E319: Engine Model Year 2024 Engine Label Error

E319

11/26/2024

MX11 Engine Label

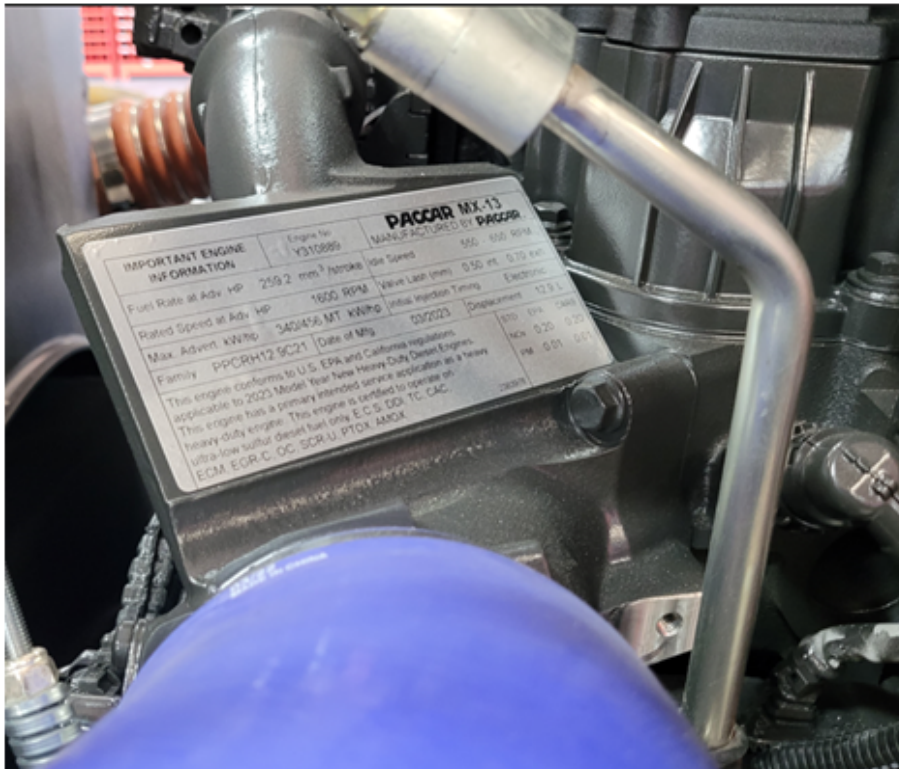
Engine Model Year 2024 may not be displayed correctly on the PACCAR MX Engine Label. New and improved PACCAR MX Engine Labels are now available to be installed.

2. Locate Engine Label on engine.

3. Remove existing Engine Label.
4. Clean surface of any remaining residue.
5. Install the new Engine Label in the same location.
6. Take a clear picture of the installed new Engine Label and attach to warranty claim.
